**1958 Agreement – Consideration of draft amendments  
to existing Regulations submitted by GRSP**

## **Proposal for Supplement 11 to the 04 series of amendments to Regulation No. 44 (Child restraint systems)**

### **Submitted by the Working Party on Passive Safety\***

- "4.9. Marking of a booster cushion without backrest.

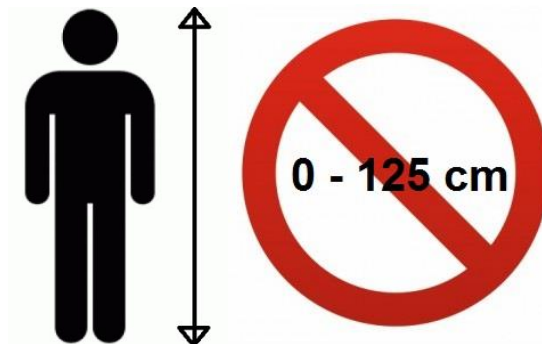
Insert a new paragraph 4.9., to read:

If the product is a booster cushion without backrest, the following label shall be permanently visible to someone installing the restraint in a vehicle and shall be masked when the booster cushion is used with its removable backrest :
